FINAL PLAT
THE GATEWAY CENTER ADDITION
AN ADDITION TO WICHITA, SEDGWICK COUNTY, KANSAS

RE: S/D 99-2 -- Final Plat of THE GATEWAY CENTER ADDITION

RE: S/D 99-2 -- Final Plat of THE GATEWAY CENTER ADDITION

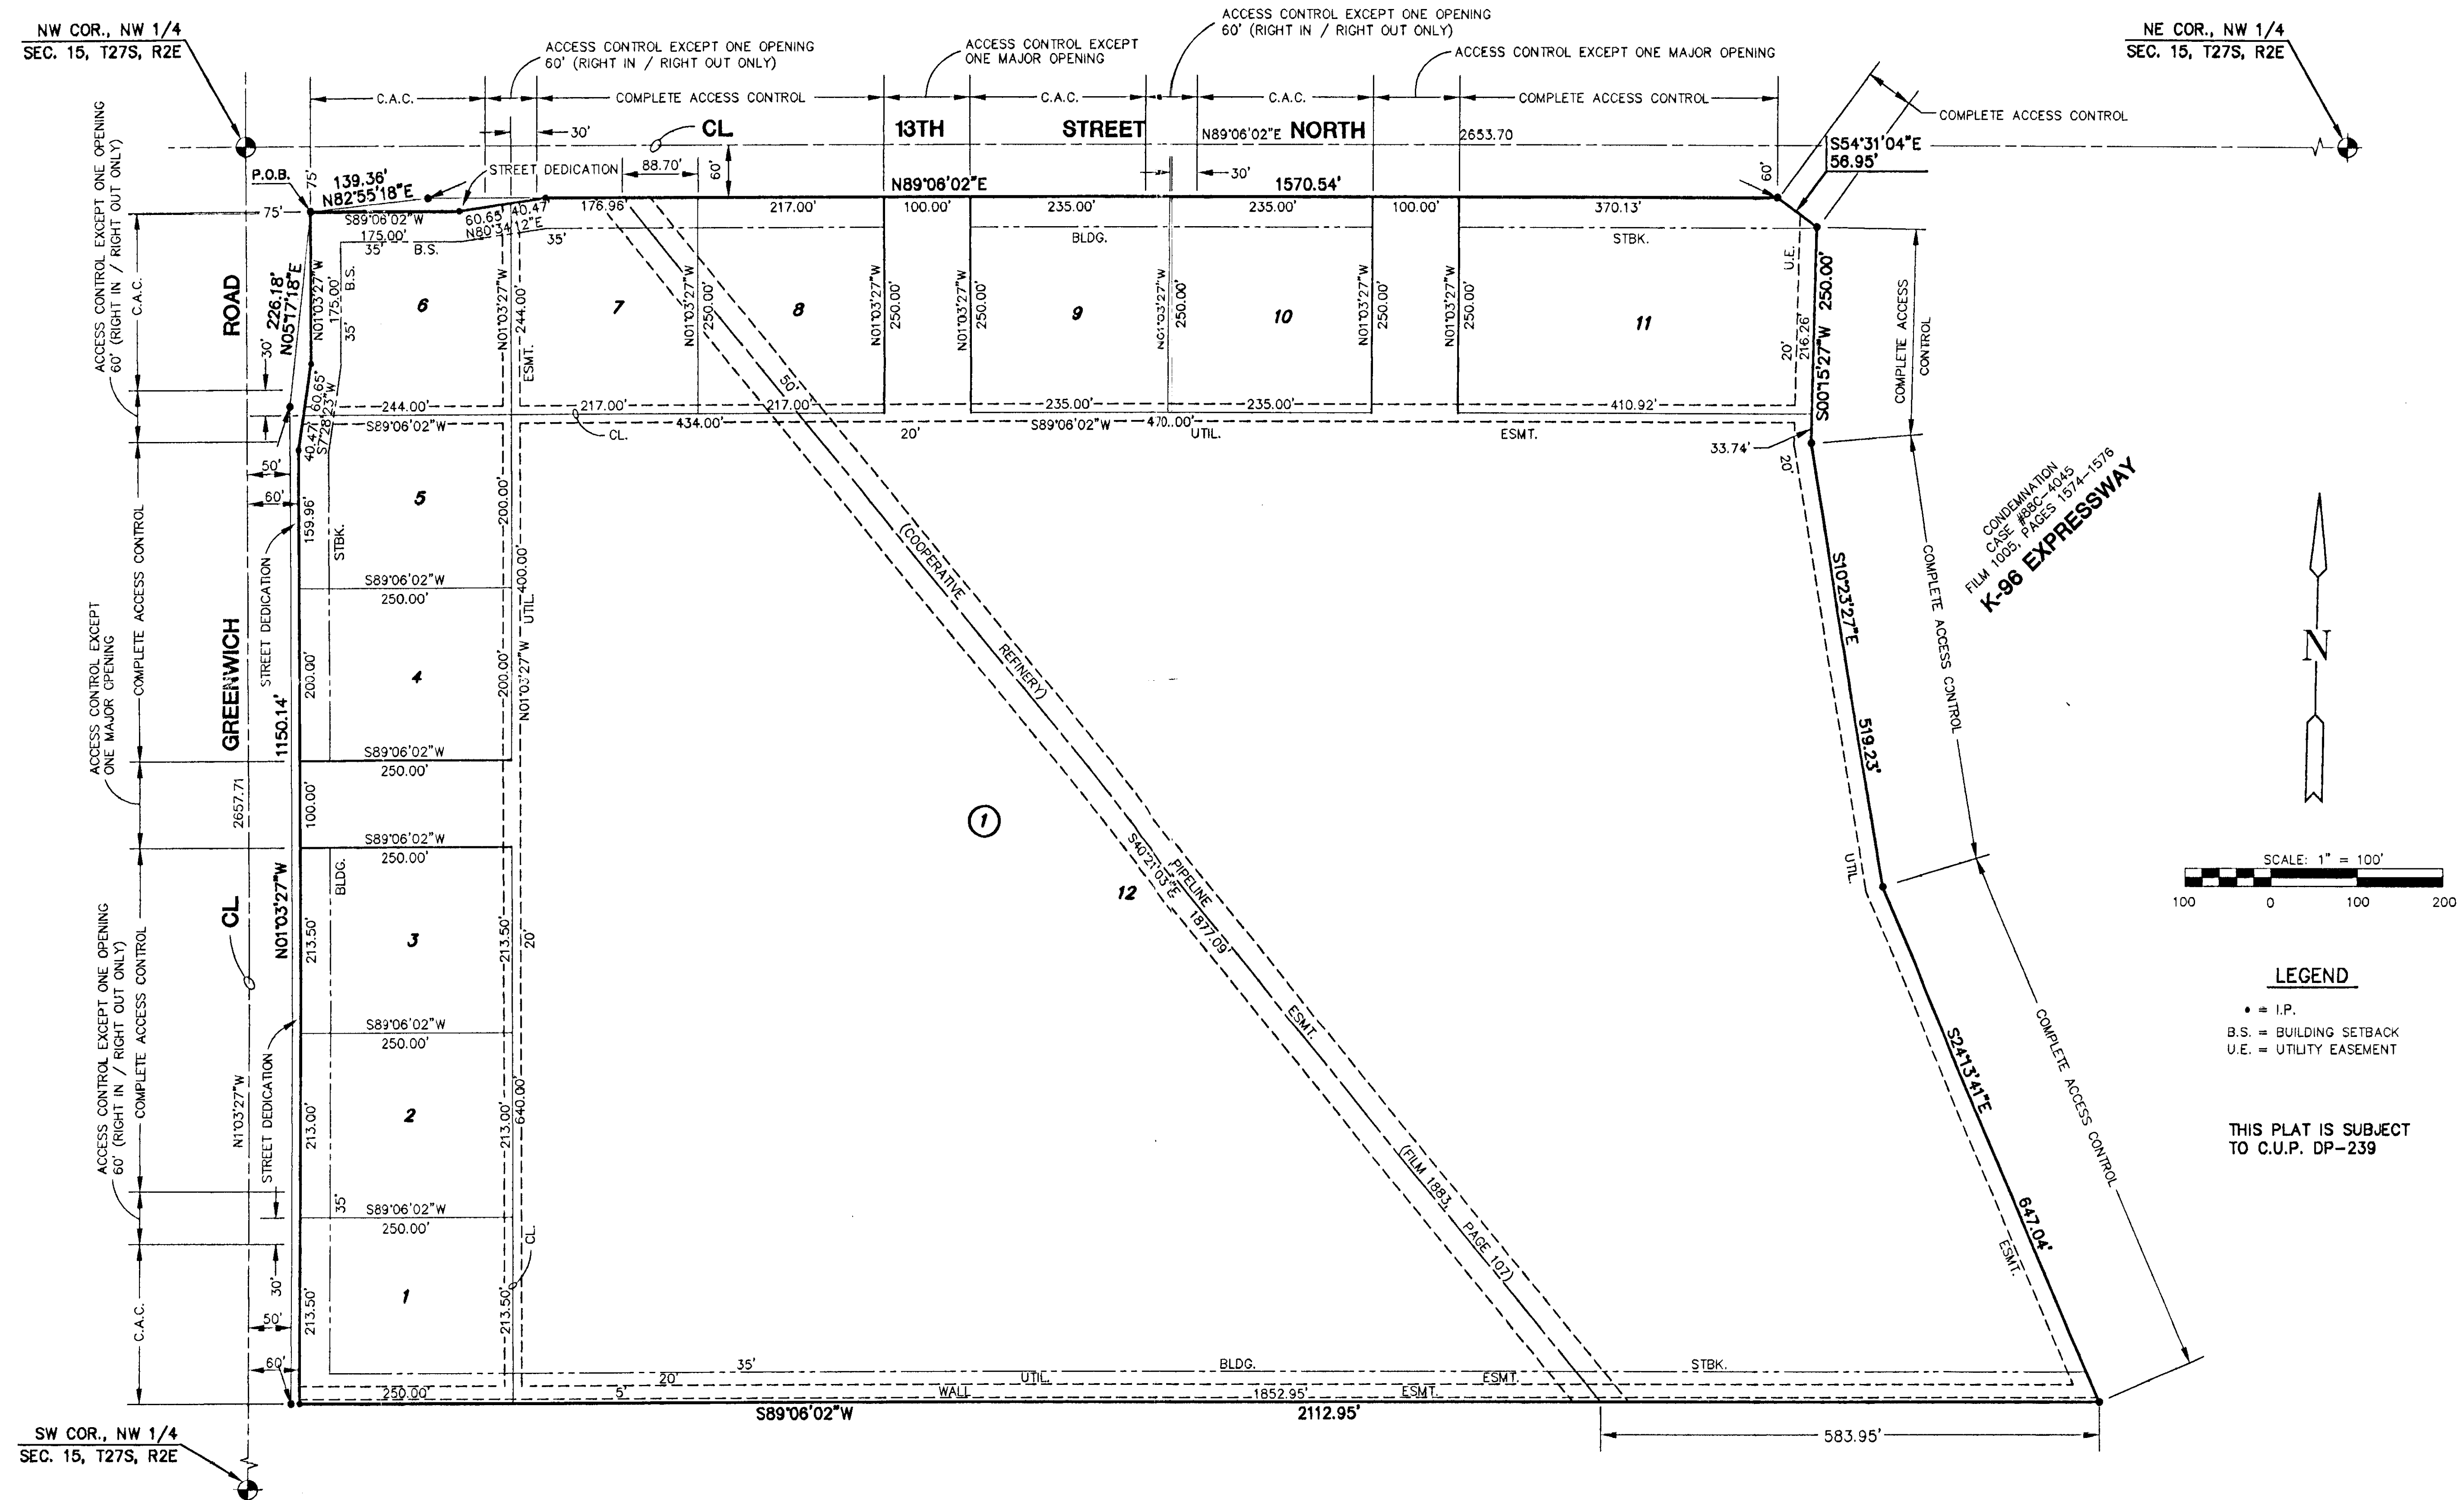
- A. As this site is adjacent to Wichita's City limits, the applicant shall submit a request for annexation. If the applicant desires to complete the plat prior to annexation, both the City and County signature blocks need to be included on the final plat.

- B. This plat will be subject to approval of the associated zone change (SCZ-0783) and CUP (DP-239) and any related conditions.
- C. This site is located in the County's Four Mile Creek sewer system and will be served by the County. County Engineering requires the submission of an off-site sanitary sewer easement.

- D. The applicant shall guarantee the extension of City water to serve the lots being platted.
- E. City/County Engineering needs to verify if any other guarantees or easements are required.

- G. City Engineering needs to comment on the status of the applicant's drainage plan. An off-site drainage easement is required. A guarantee is required for drainage improvements.

- H. The plat denotes five access openings to Greenwich Road and seven access openings along 13th St. North. The Subdivision regulations encourage shared access points for multiple lot commercial subdivisions along arterials.

Traffic Engineering needs to comment on the acceptability of the access controls. Any joint access easement shall be established by separate instrument. Distances should be shown for all segments of access control. Traffic Engineering has approved three openings from the property to Greenwich and four openings to 13th St. North. On Greenwich, the northernmost of the three openings is limited to right turns in and out. A joint access between lots 1 and 2, a major opening between lots 3 and 4, and a joint access between lots 5 and 6 are approved along Greenwich. On 13th St. North, two of the four permitted openings will be major openings (one shall align with Chapel Hill Road and the other shall align with the entrance to Dillons north of 13th Street North) with left and right turns, and the other two openings shall be limited to right turns in and out (one shall be a joint access opening between Lots 6 and 7 and the other shall be located between lots 9 and 10).

- I. The applicant shall submit a copy of the instrument which establishes the pipeline easement on the property, which verifies that the easement shown is sufficient and that utilities may be located adjacent to and within the easement. The final plat tracing shall also indicate the recording information for the pipeline easement.

- J. The applicant's agent shall determine any setback requirements for the pipelines by researching the text of the pipeline agreements. If a setback from the pipeline easements is provided for in the pipeline easement agreements, it shall be indicated on the face of the plat and further noted that the setback is a building setback line for the Farmland Industries pipeline.

- K. Traffic Engineering needs to comment on the need for any improvements to perimeter streets. In accordance with the zone change (SCZ-0783) and CUP (DP-239) Traffic Engineering has required the following: Along 13th Street North a continuous eastbound accel/decel lane shall be guaranteed from Greenwich to the K-96 on-ramp; plus a center median with two openings, one at Chapel Hill Road and the other to line up with the entrance to Dillons north of 13th St. North; if no median is constructed, the two minor openings shall be designed with raised diverter medians to only permit right-turn movements; and the applicant shall guarantee a portion of the cost of signalization at the intersection of 13th St. North and one of the major openings.

Along Greenwich Road, the Applicant shall guarantee a temporary left turn southbound lane as long as Greenwich remains a two lane road. The Applicant shall guarantee a permanent southbound left turn lane to the major opening when Greenwich becomes a four-lane road.

- M. The final plat shall indicate that the Addition is subject to the conditions of the associated CUP.
- N. The name of all owners who are signatories on this plat must be printed beneath their signature.

- V. The representatives from the utility companies should be prepared to comment on the need for any additional utility easements to be platted on this property. Southwestern Bell has requested additional easements.
